### **MANLY NATIONAL BUILDING PROPOSED CARPARKING COVERING 22 CENTRAL AVENUE, MANLY**

As requested we have reviewed your proposal to add lightweight carpark coverage to areas of the National Building, 22 Central Avenue Manly.

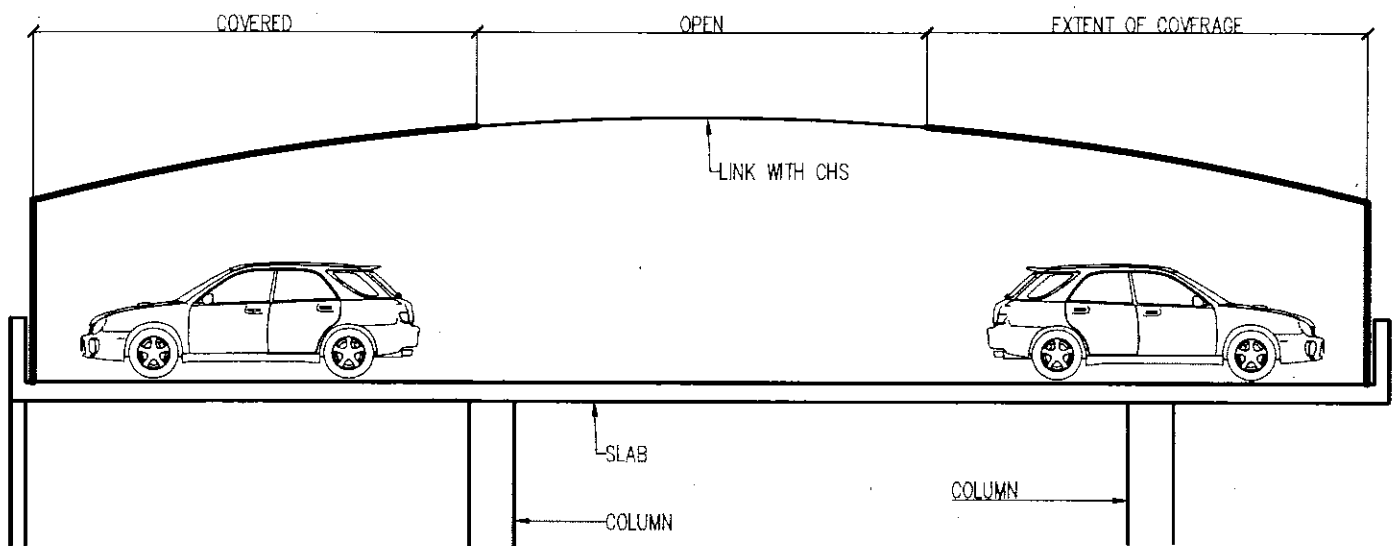
In comparing both schemes the base building appears to have adequate capacity to support the light weight addition(s).

We note that in both scenarios the location and detailing of the columns requires confirmation.

The drawback of the STRATCO option is the location of columns within the aisle and the obvious restrictions to parking and manoeuvring.

The ABACUS proposal concentrates load at each cantilever base fixing point which will require careful detailing to avoid impacting drainage.

A hybrid option may be considered. This is based on a spanning frame similar to the ABACUS proposal with coverage limited to cover the cars but to have the portal frame structure span the full width of the carpark.

This reduces the fixity requirements at the baseplate while maintaining a similar bending moment and section size.

Placing columns within the parking spaces will restrict parking access.

We recommend that consideration be given to a hybrid option as nominated above.
